Wilpinjong Coal Mine

Modification 3 - Pit 8 Extension Response to Submissions Report

Peabody

Figure 8

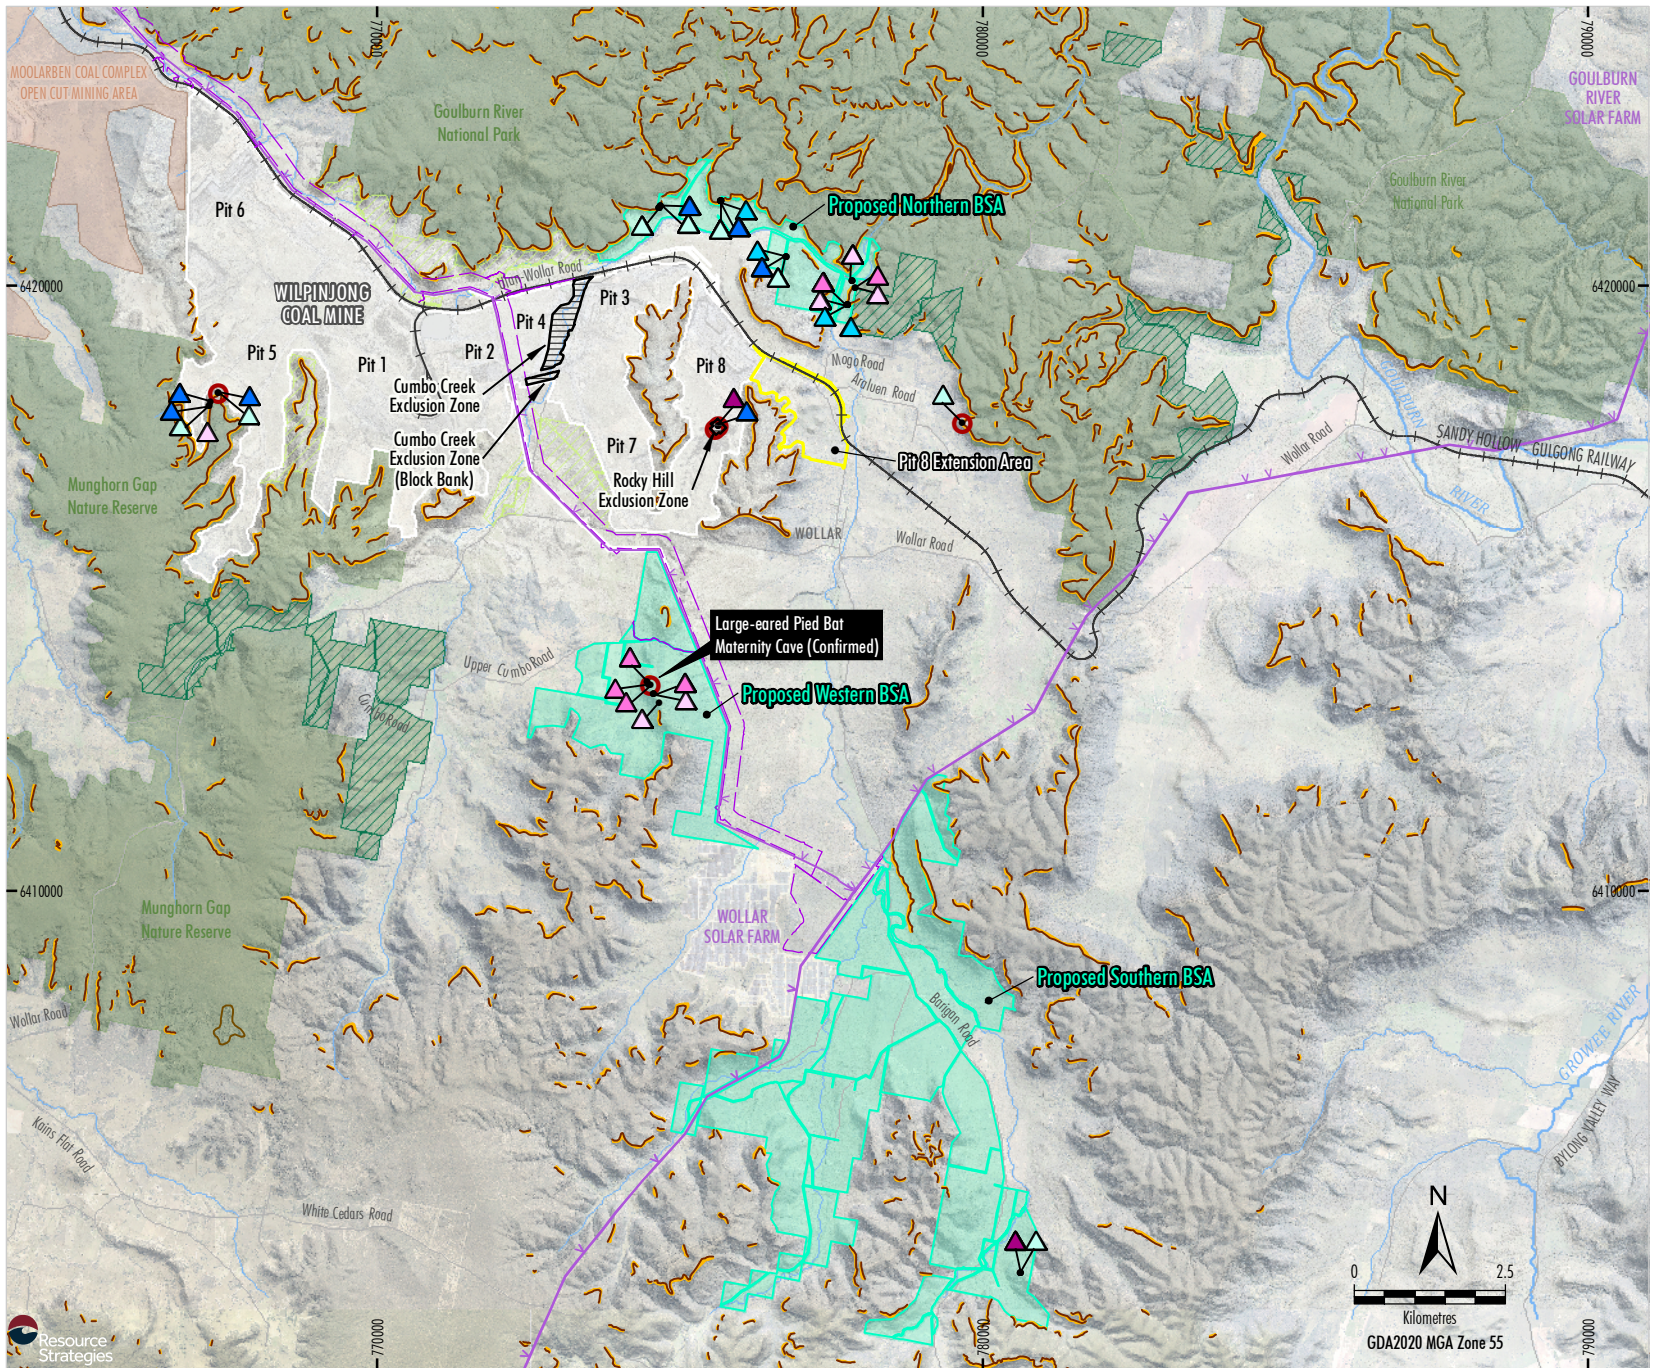
Recommendation 7.1

In the absence of detailed rock mass strength surveys being conducted prior to approval, establish a poor quality rock peak particle velocity threshold for the western escarpment prior to project approval.

Based on the above, and the response provided to Recommendation 3, WCPL concluded that a 100 m setback from rocky habitat is not reasonable or required.

Also of note, species credits would be provided for the Large-eared Pied Bat and Eastern Cave Bat consistent with the requirements of the BAM. There is evidence of breeding individuals within the proposed BSAs (Figure 8).

Figure 14

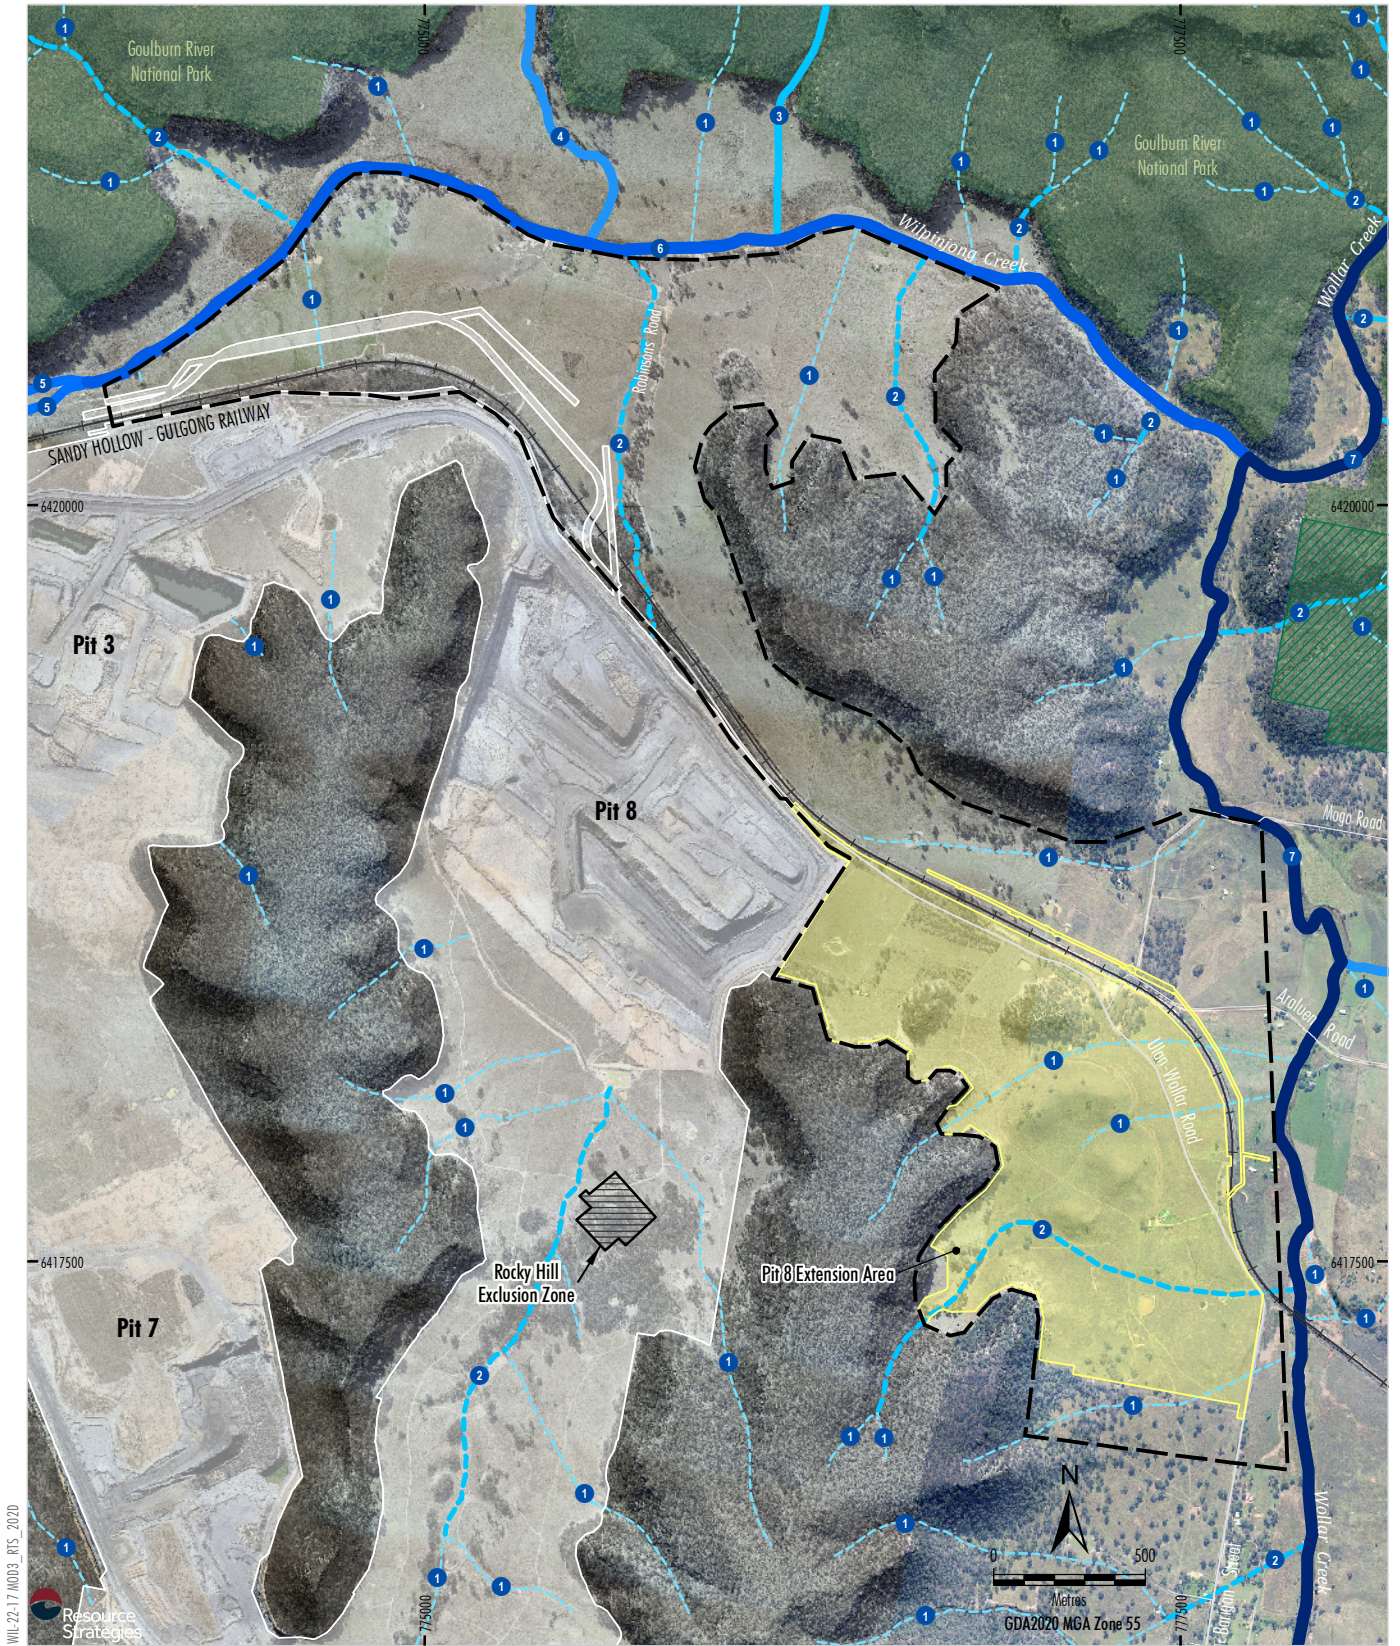
The test excavation program focused on a 200m buffer around waterways; however, results show artefact density did not correlate with proximity to water. For example, Transect 8, outside the buffer, recorded the highest density (47.43 artefacts/m²), while Transect 4 along Wilpinjong Creek had the lowest (5.33 artefacts/ m²). This indicates that factors other than water proximity influences Aboriginal occupation. Heritage NSW also notes that, following the November 2024 project design update, only one testing area related to the Modification Area and no test excavations were undertaken within the proposed disturbance footprint. Heritage NSW recommends revising the testing strategy and undertaking additional testing in areas beyond the 200 m buffer in areas proposed for disturbance. The predictive model and discussion must also consider the current mismatch between expectations and findings.

Navin Officer has prepared a Technical Response to Comment #10 that is provided in Attachment 5. The below summarises Navin Officer’s response and provides additional discussion where relevant.

The test excavation program was developed using the ACHA predictive model, which identified areas of higher subsurface archaeological potential (often near watercourses) within the Study Area. It is important to clarify that artefact density did in fact correlate with proximity to water sources within the Study Area, consistent with long-term patterns of land use in the region.

For instance, Transect 8, whilst outside the 200 m buffer of a named creek, was located adjacent to an unnamed second-order watercourse (Figure 14). Navin Officer has noted that prior to broadscale European disturbance of the landscape, this watercourse would have provided a water source for Aboriginal activity, primarily camping and food gathering, which explains why Transect 8 yielded the highest artefact density (47 artefacts per square metre [artefacts/m²]) despite not being adjacent to a named creek (Attachment 5).

Figure 17
Modelled Maximum Extent of VLAMP Criteria

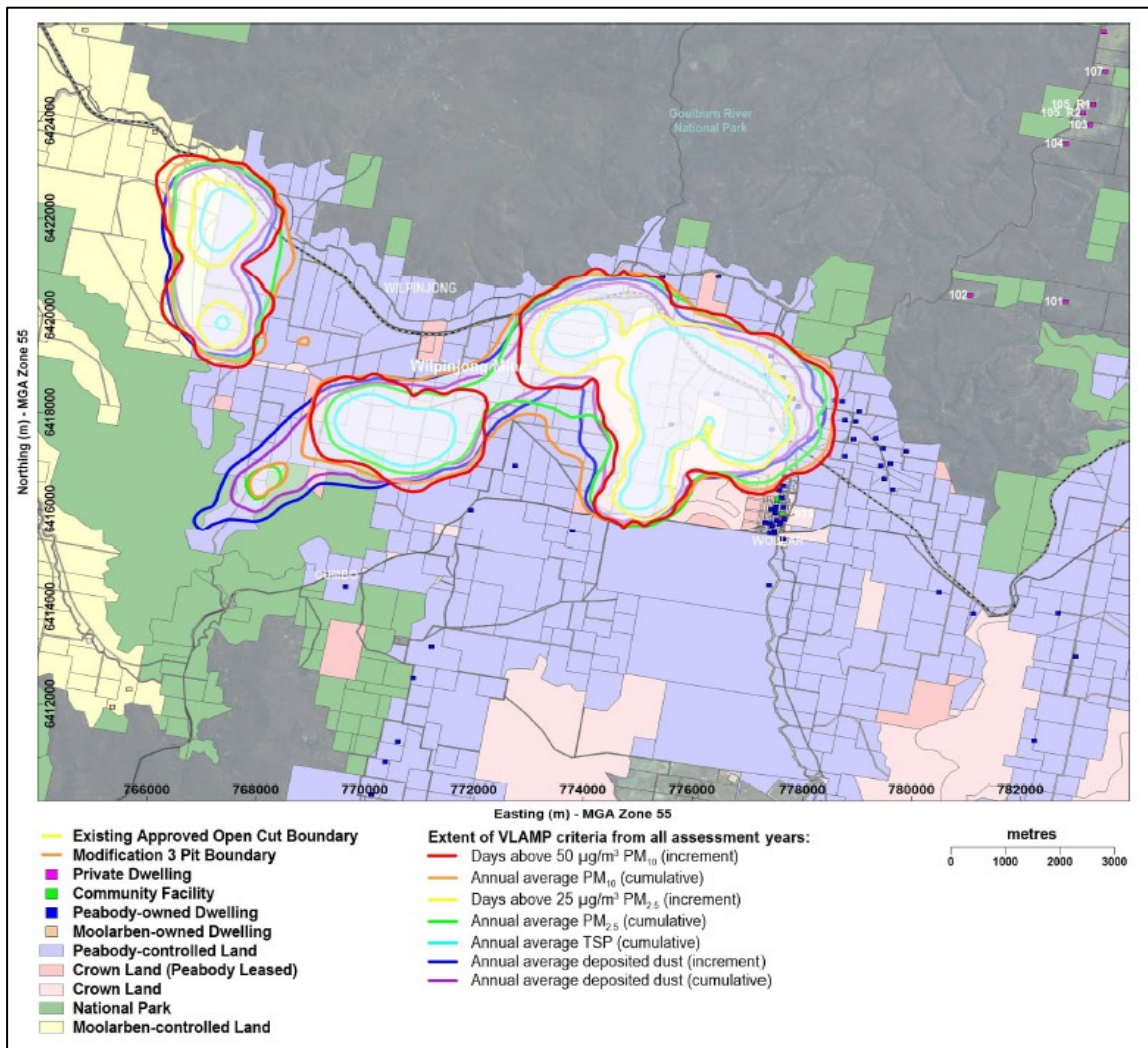
Members of the community raised a concern that the VLAMP vacant land assessment in the AQIA did not consider the recent grant of (formerly) Crown Land to the MLALC.

Notwithstanding, WCPL has reviewed the maximum extent of VLAMP criteria based on all years of assessment and for all relevant air quality indicators as presented in the AQIA as Figure 24, replicated as Figure 17 below and concluded compliance is demonstrated for all air quality indicators and averaging times prescribed by the VLAMP for all vacant land parcels granted to the MLALC.
